City of San Antonio
TRANSPORTATION AND CAPITAL IMPROVEMENTS

ADDENDUM No. 2

PROJECT NAME: Menger Creek Drainage – ID NO.:40-00328

DATE: August 4, 2015

ADDITIVE ALTERNATIVE PLAN
STA. 0+00 TO STA. 4+99.58

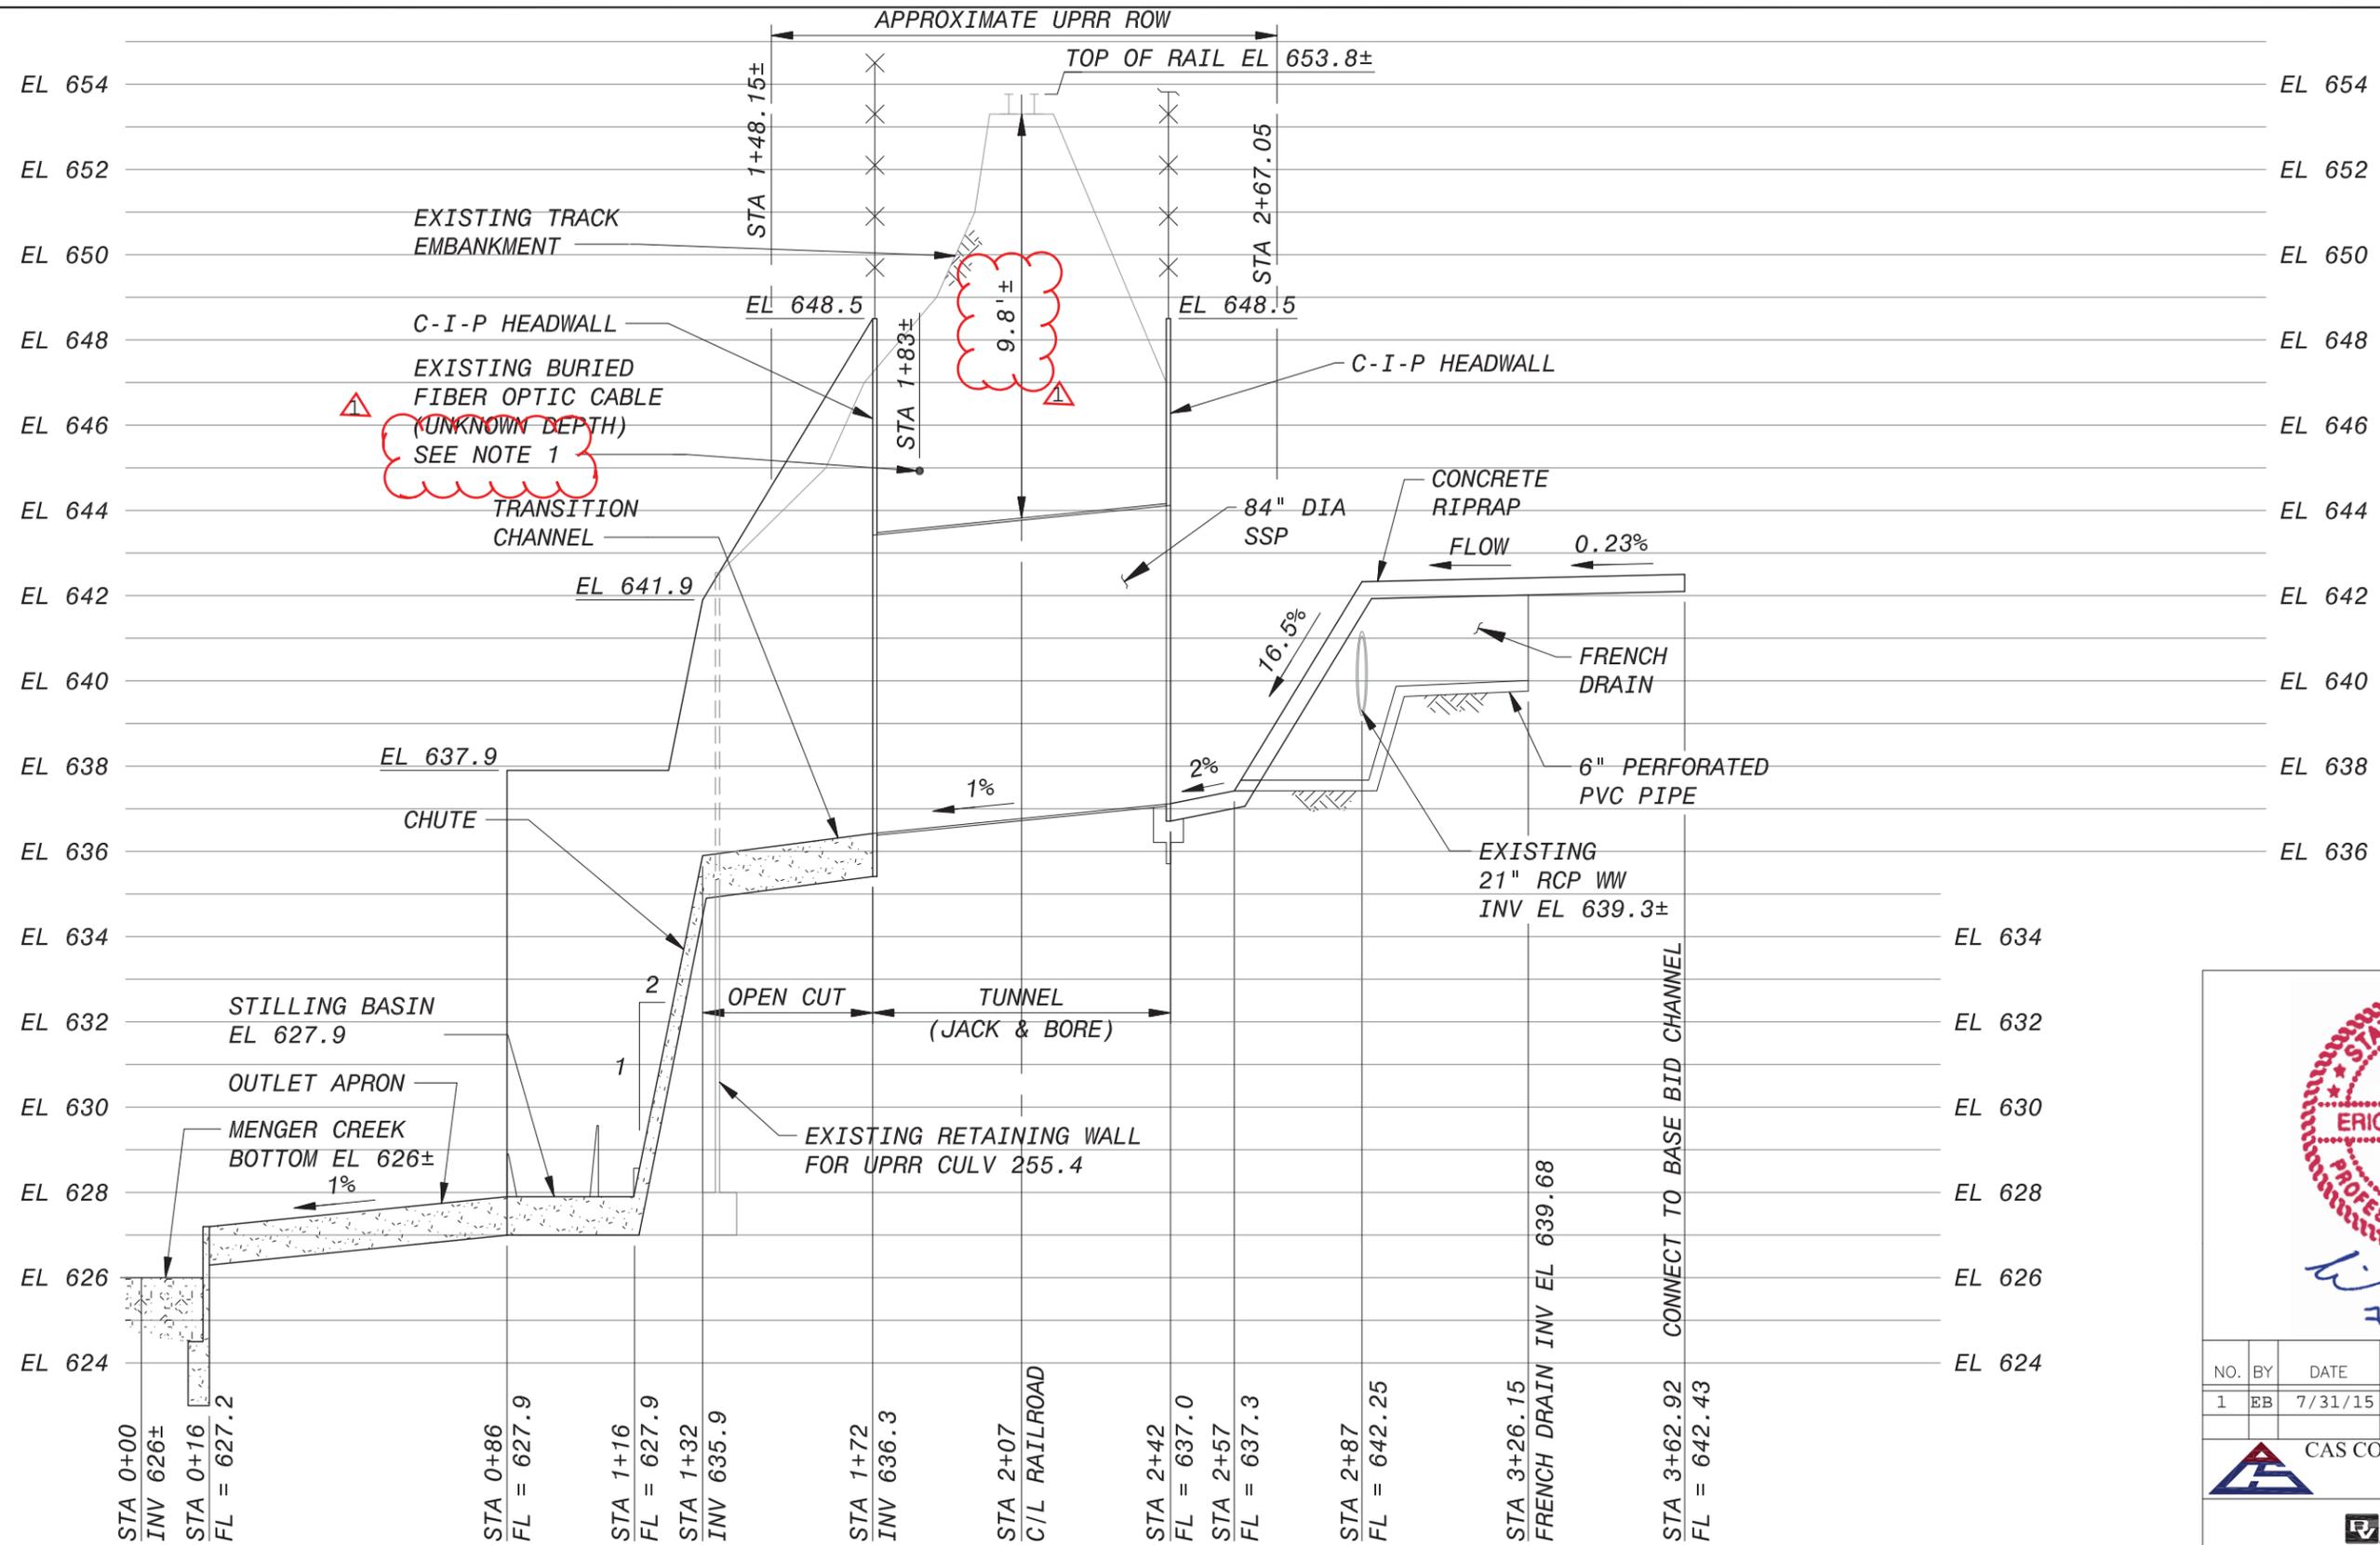
NO.	BY	DATE	REVISION DESCRIPTION
1	EB	7/31/15	Misc. Clarifications

RAILROAD CROSSING CULVERTS
 1
 C-86
 1/8" = 1'-0"

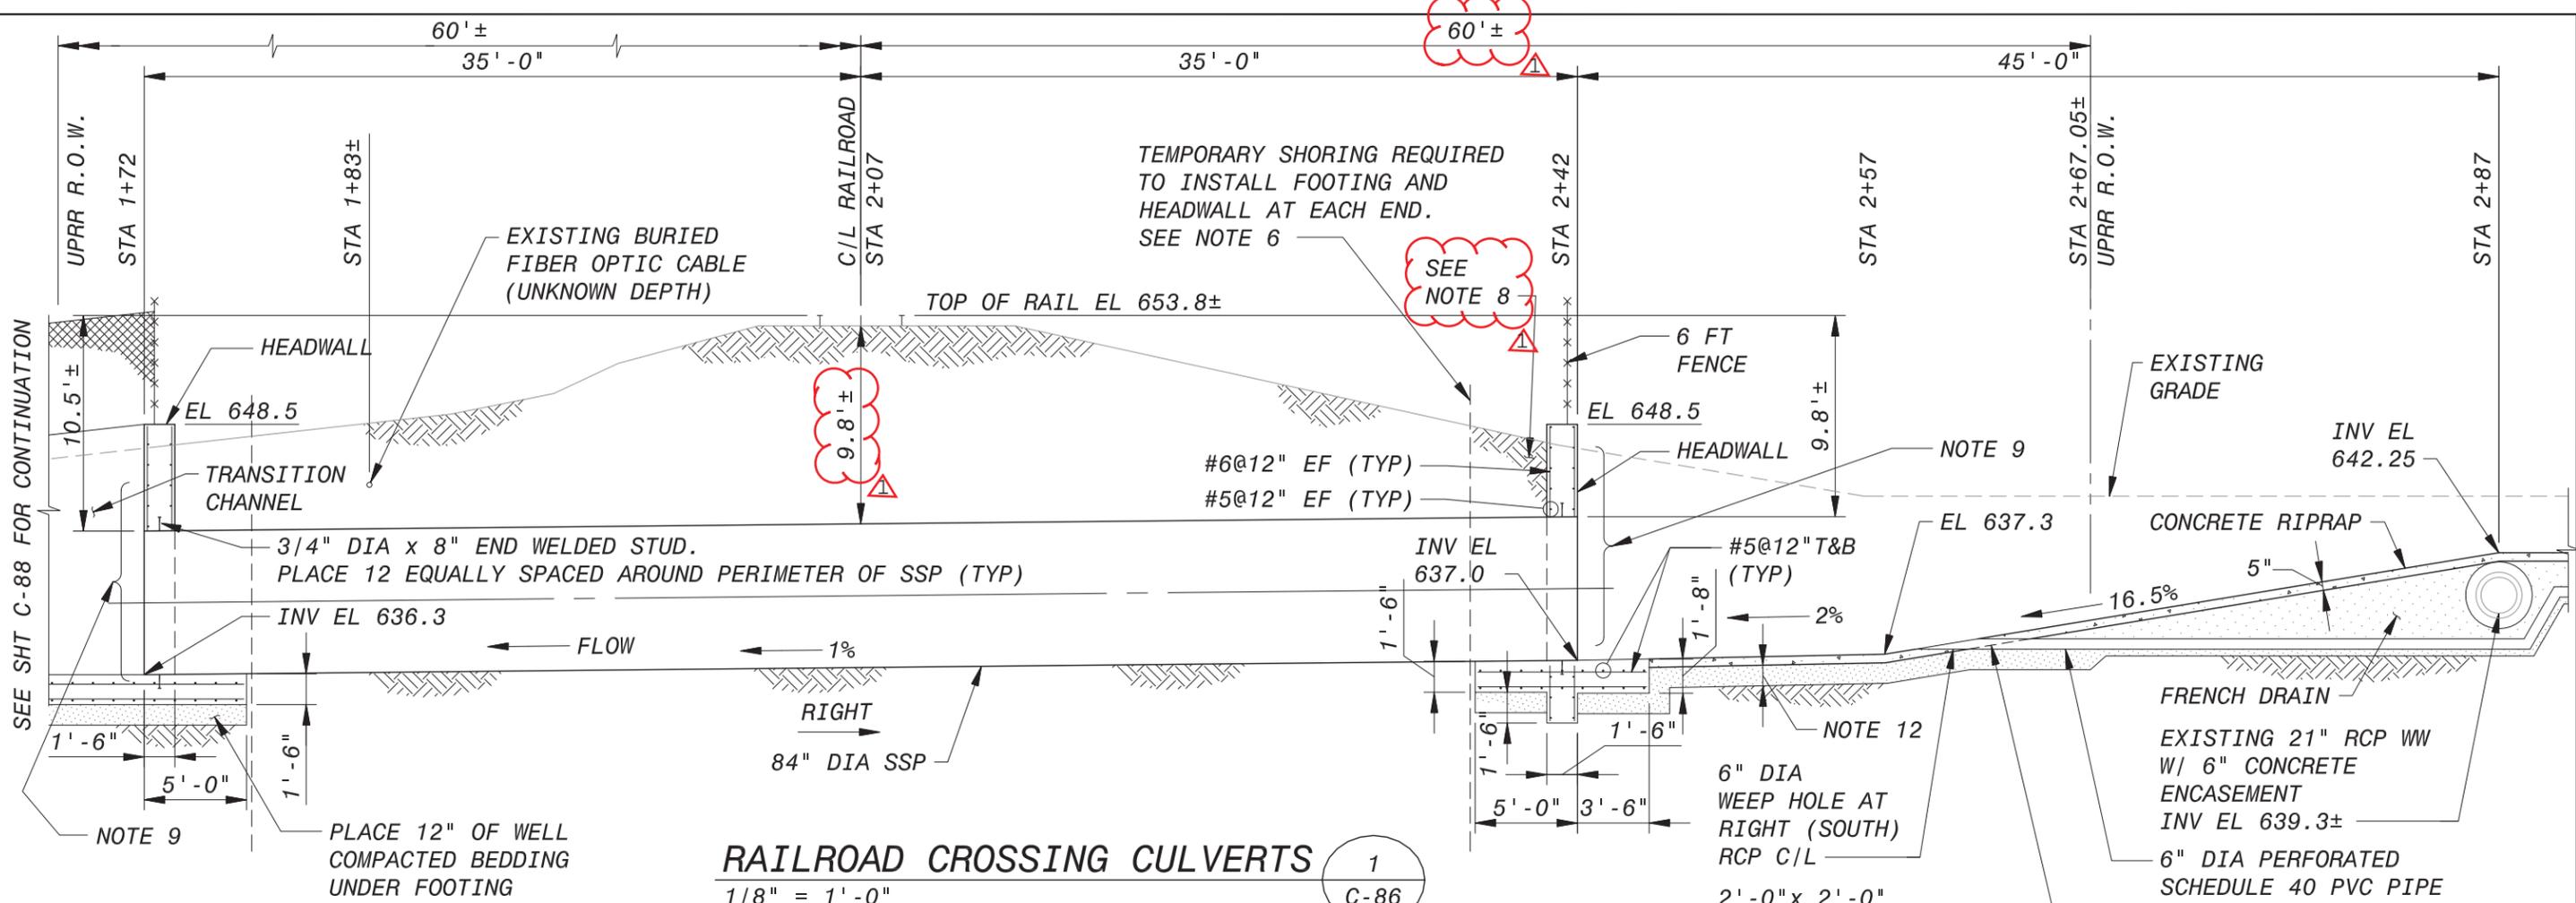
6. Sheet C-87 Note 5: What will the railroad insurance requirements be?
 - *UPRR insurance requirements will be provided by the City before the start of construction.*

- *Train schedules are not available, other than an average of 18 trains passing thru the project area daily.*
11. Sheet C-87 Note 4: Can you please provide AREMA Chapter 2, Part 4 as part of the specs?

12. Sheet C-87 Note 10: States Clay beneath slabs to be 1,500 psi min.
 - a) If not 1500 psi, what will it be?
 - Contractor to test the clay and evaluate the bearing pressure. If it isn't 1,500 psi, over-excavation will likely be needed, item would be a change to the contract and negotiated as such.
 - b) Over Excavate for it? How Much? Place with what?
 - If it isn't 1,500 psi, over-excavation will likely be needed, item would be a change to the contract and negotiated as such.

15. C-87 and C-89: Footing width of wall 11'-6" tall detail 1-C-86 on sheet shows 8'-6"
 - a) What is the footing width dimension for walls 7'-0" tall on both sides of this wall?
 - The headwall footings are typical and extend the entire length of the headwall, the downstream outlet walls are shown in the details on sheets C-91 and C-92.
 - b) Is wall thickness the same as 11'-6" wall at 1'-6"?
 - The wall thickness is 1'6".

10. CONTRACTOR SHALL CONFIRM THE ALLOWABLE BEARING ON CLAY BENEATH SLABS ON GRADE IS 1500 PSF MIN.
11. SEE ADDITIONAL REINFORCEMENT AT OPENINGS OF HEADWALL IN SECTION 1 ON SHEET C-89.

PLAN MARK	MINIMUM ROUGH-IN SIZES				DESCRIPTION
	WST & VENT	DRAIN	CW	HW	
DF-1	1 1/2"	1 1/2"	1/2"	---	AS SPECIFIED BY LANDSCAPE ARCHITECT.

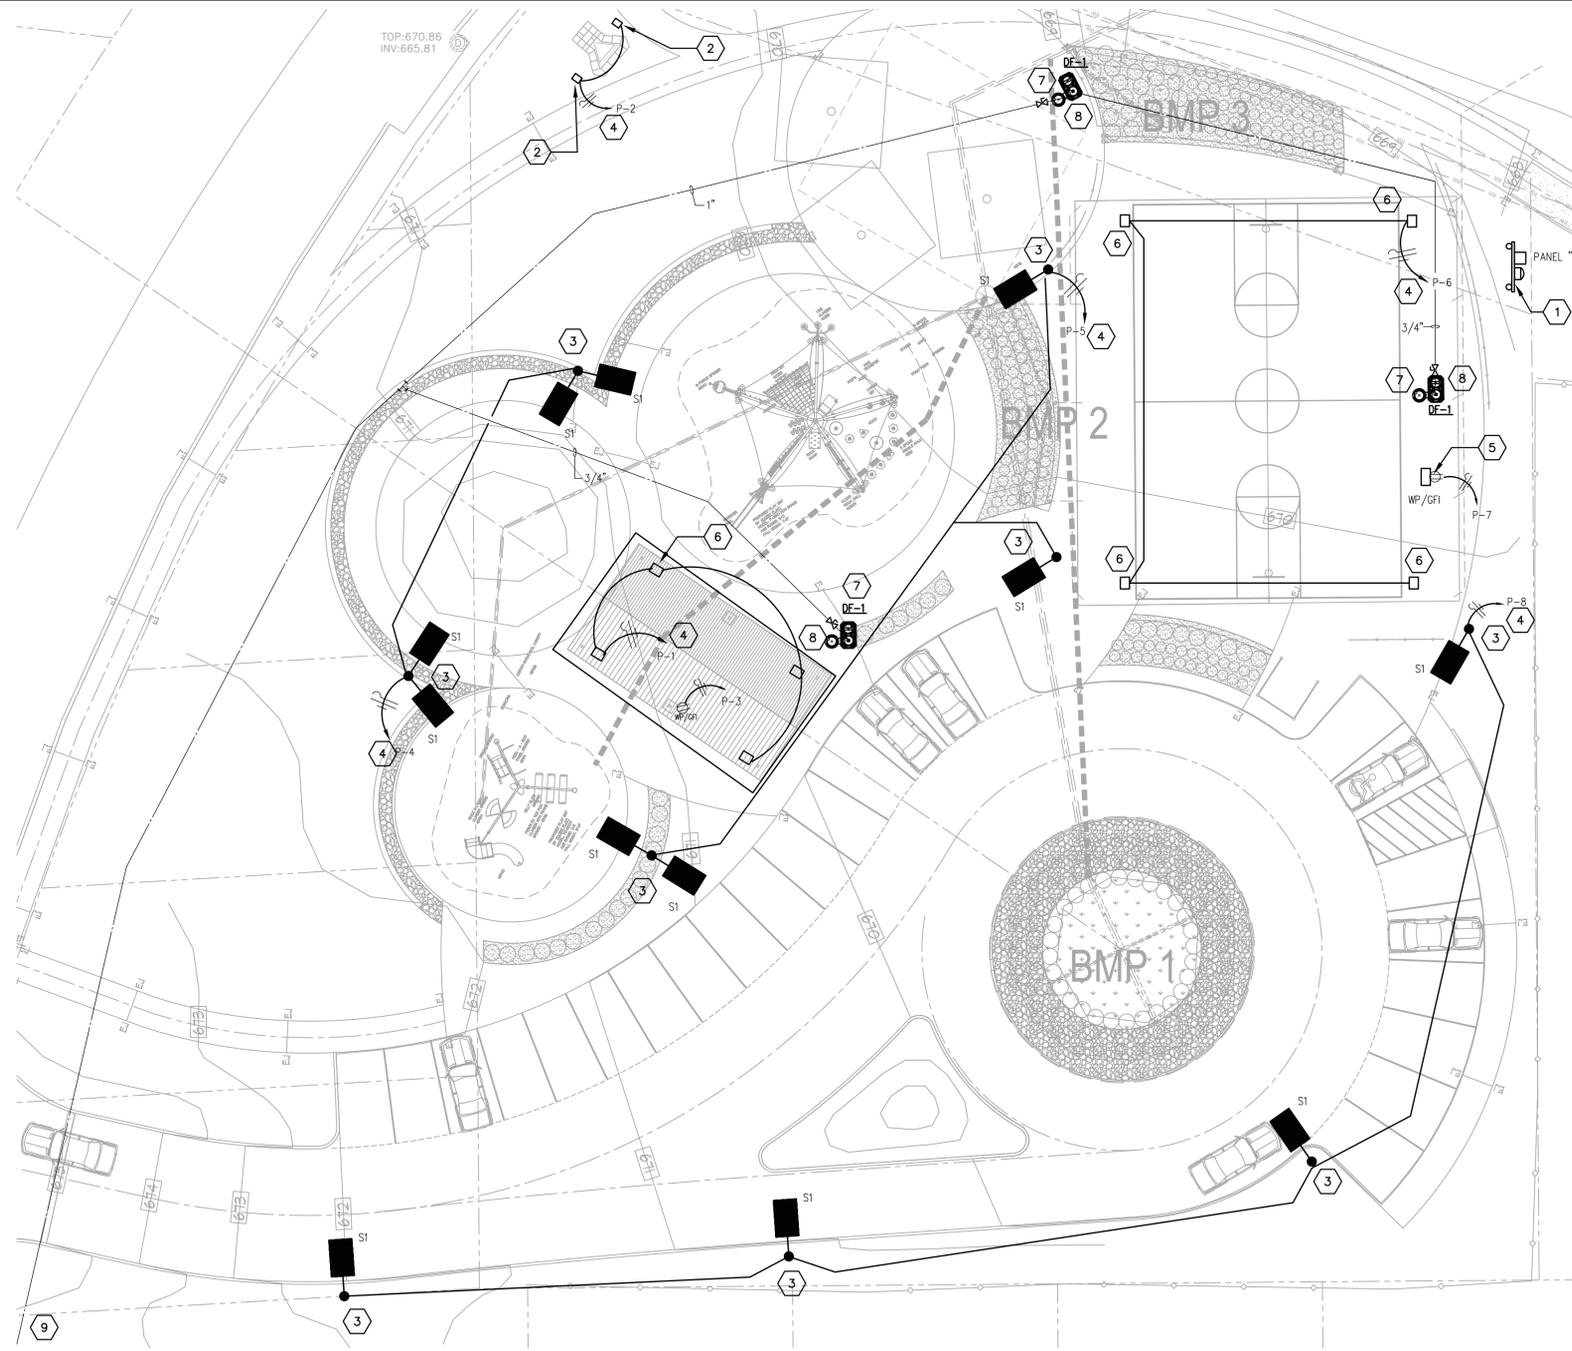
- o The City of San Antonio Parks & Recreation logo should have an overall dimension of 1'-6" ht. x 1'-5" width.
8. "Detail 3: French Drain for DF-1" on Sheet EPS 1.0 has been updated. See attached Sheet EPS 1.0

- 7 CONTRACTOR SHALL PROVIDE AND INSTALL NEW DRINKING FOUNTAIN DF-1 PER DETAIL 3/EPS1.0. COORDINATE EXACT LOCATION WITH OWNER/ARCHITECT. PROVIDE A FRENCH DRAIN FOR THE NEW DRINKING FOUNTAIN AS DETAILED ON THIS SHEET. CONTRACTOR SHALL PULL AND EXTEND THE EXISTING WATER LINE FROM EXISTING METER TO NEW DRINKING FOUNTAIN. CONTRACTOR SHALL FURNISH AND INSTALL A CAST IRON VALVE BOX FOR NEW VALVE PER 2/EPS1.0. CONTRACTOR SHALL BE RESPONSIBLE FOR LOCATING WATER SOURCE ON SITE PRIOR TO BID TO ESTABLISH EXACT PIPING ROUTE AND LENGTH.

- 8 DRY WELL FOR DRINKING FOUNTAIN DRAIN. REFER TO DETAIL 3/EPS1.0.
- 9 EXTEND AND CONNECT TO THE EXISTING WATER METER. FIELD VERIFY EXACT LOCATION PRIOR TO BID. CONNECT NEW DRINKING FOUNTAIN TO EXISTING DOMESTIC WATER SOURCE. PROVIDE A PVB BACKFLOW DEVICE WITH CAGE.
